W3F1-2010-0050

**Subject:** Response to Request for Additional Information Associated with  
Technical Specification Table 3.4-1 Isolation Valve Addition  
Waterford Steam Electric Station Unit 3  
Docket No. 50-382  
License No. NPF-38

**Response to Request for Additional Information**

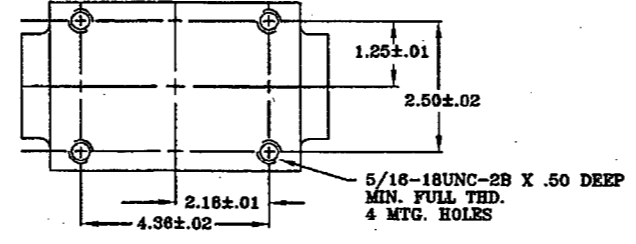
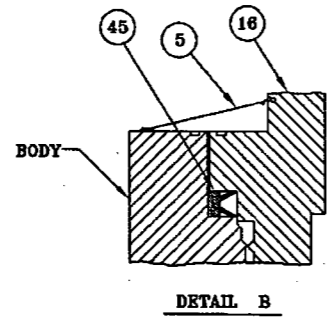
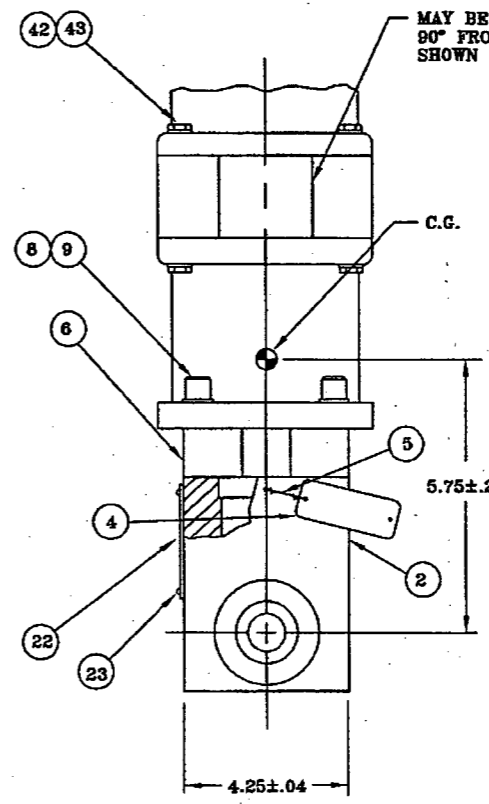
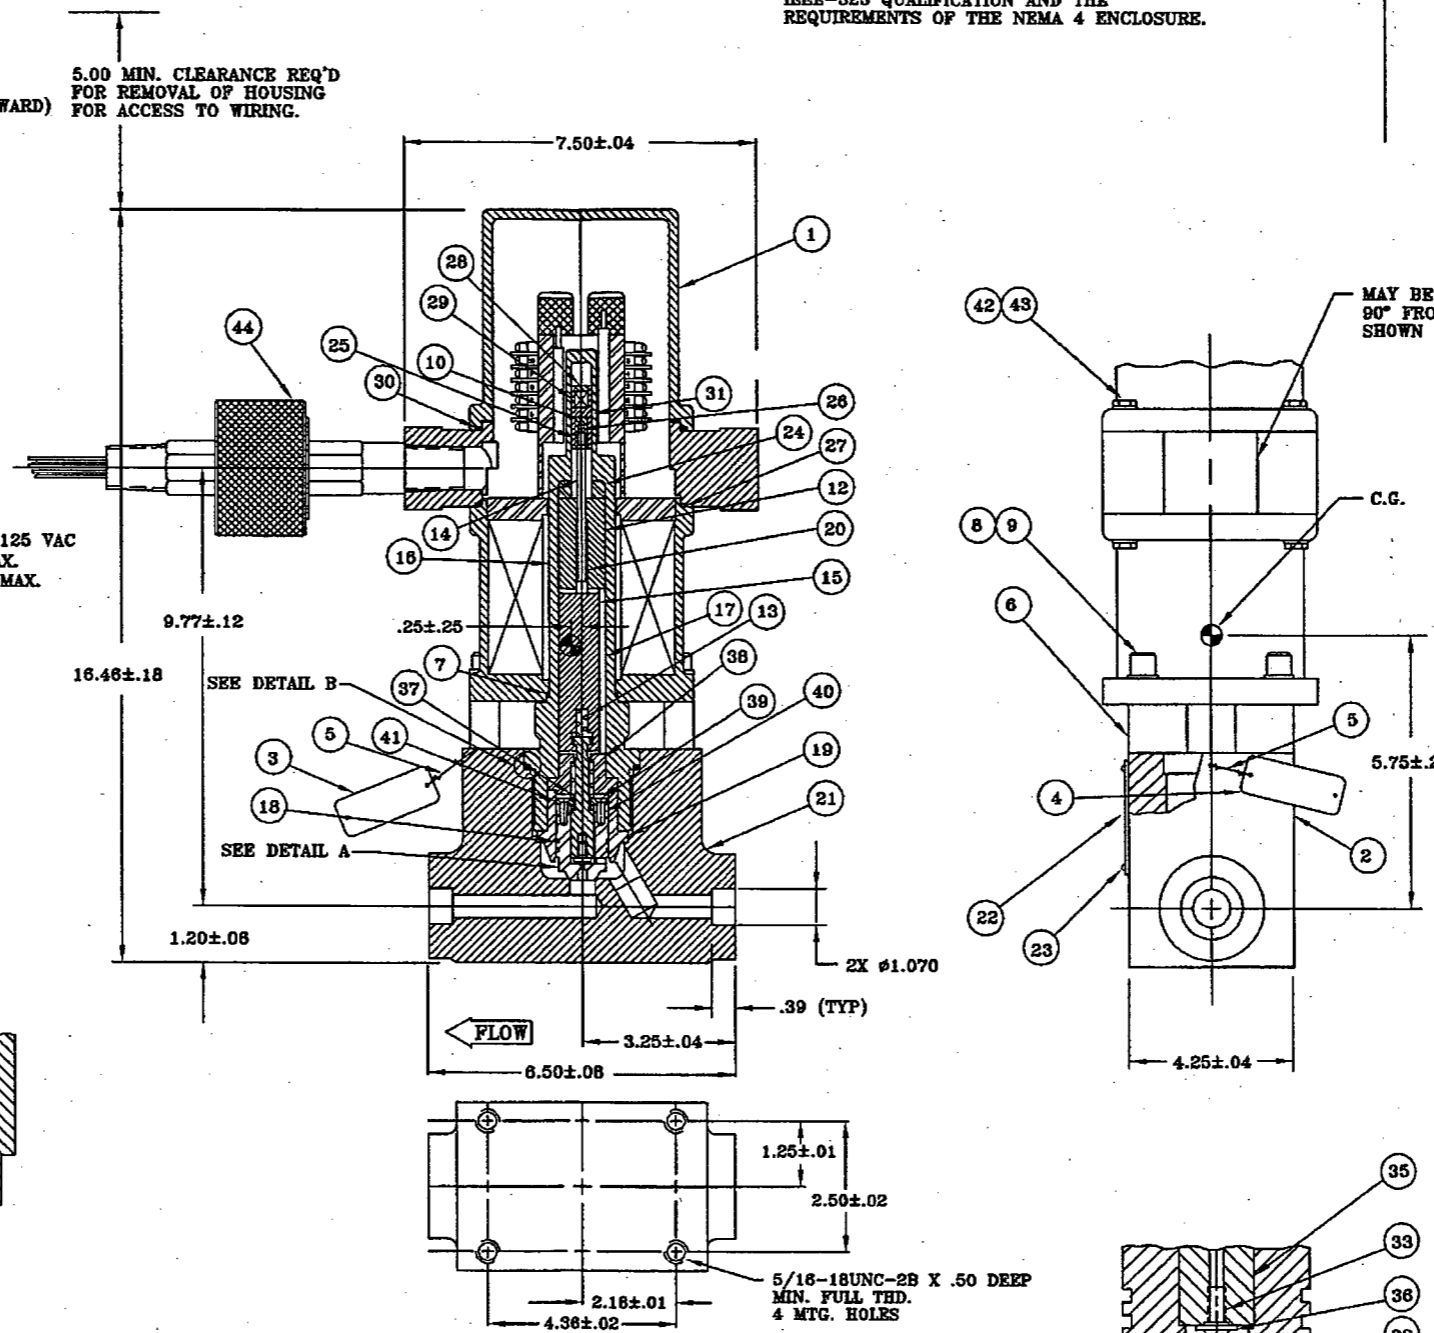
Provide name plate ratings and procurement details of the solenoid valves.

The preliminary valve drawing no. 2141673xx (attached) from the manufacturer (Valcor) reflects a nameplate primary pressure rating of Class 1717 and pressure boundary design of 2485 psig at 650 deg. F. The solenoid valves are being procured in accordance with Waterford-3 Specification 1564.110A (Control Valves & Accessories & Line Service Solenoid Valves Safety Class 1, 2, 3 & Non-nuclear Safety Class). Procurement requirements / details are as follows: 3/4" Diameter, Schedule 160, Socket Weld, Class 1E qualified to IEEE-323, ASME III, Class 1, Seismic Cat. 1, Borated Water Service, Stainless Steel Body, EGS type ECSA Conduit Seal, Radiation Environment  $5.1 \times 10^7$  rads, with independent limit switches (2) normally open and (2) normally closed.

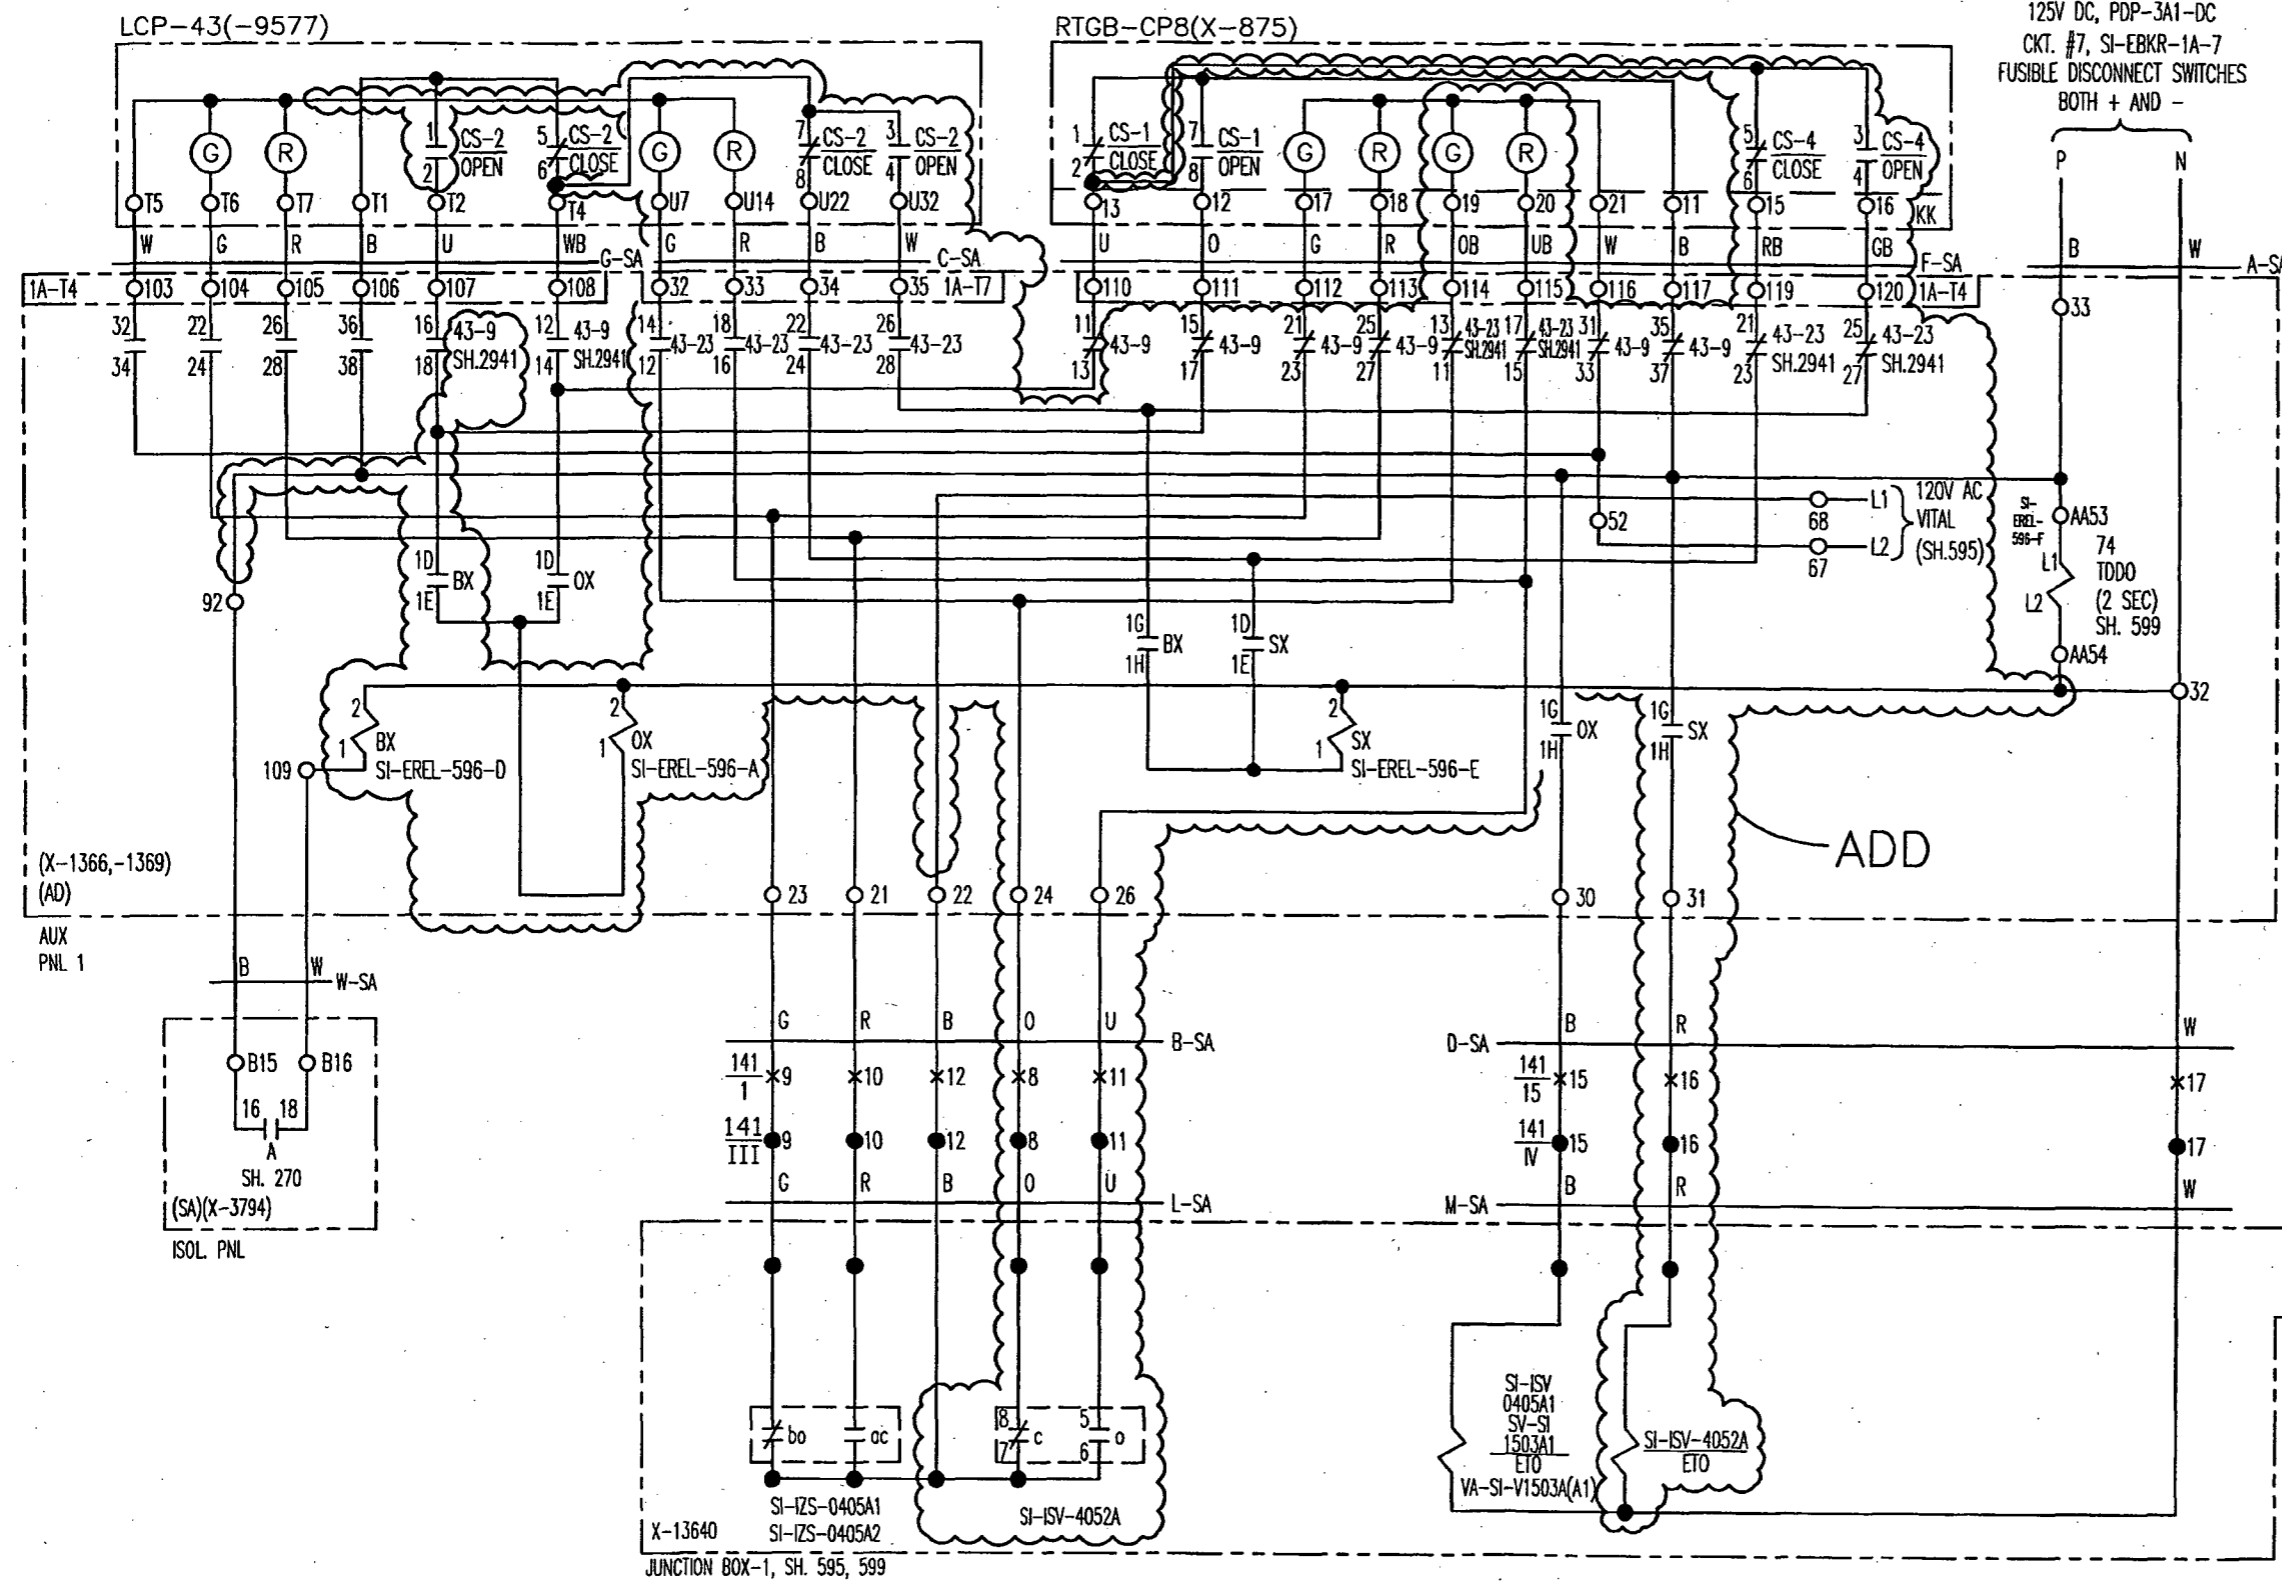
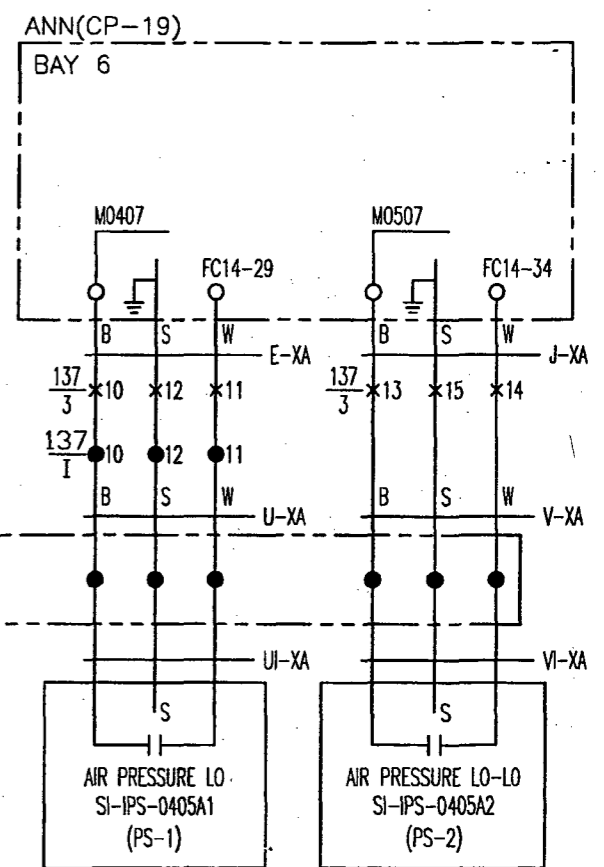
Provide the electrical one line and applicable schematic drawings showing the power and control circuits for valves SI-4052A and SI-4052B.

Drawings B424 Sheets 596, E596, 595, and E595 are the schematic drawings showing the power for valve SI-4052A and its indication lights.
